PRODUCT BULLETIN

Bulletin No: PB374

NEW G2 Series Blades for the HAKKO FT-801 Thermal Wire Stripper

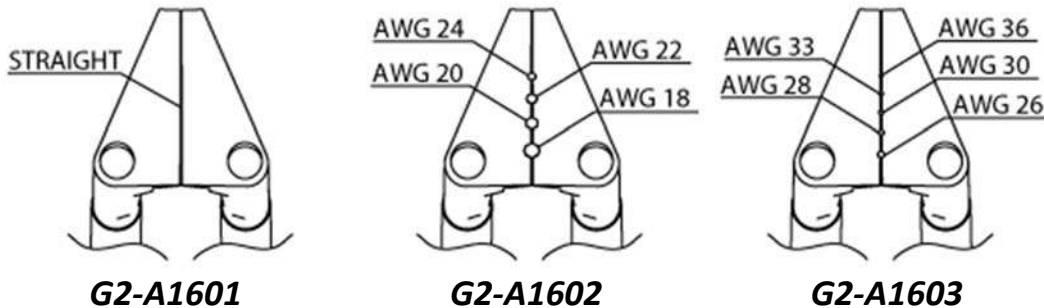
These new G2 Blade Sets for the HAKKO FT-801 Thermal Wire Stripper include a wishbone support between them that is attached to the collar. This support mitigates rotational play in the blades to improve notch alignment at the end of the blades when tighter tolerances are required.
